ADA Curb Ramp New Construction Inspection Form (Perpendicular)

Nw 285

24952.54

Nw mays

PERPENDICULAR RAMP (PR)

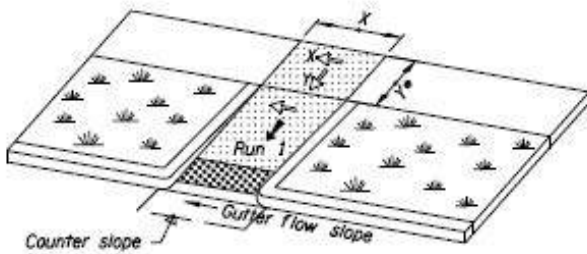
8.62

ICRR RR1 fail
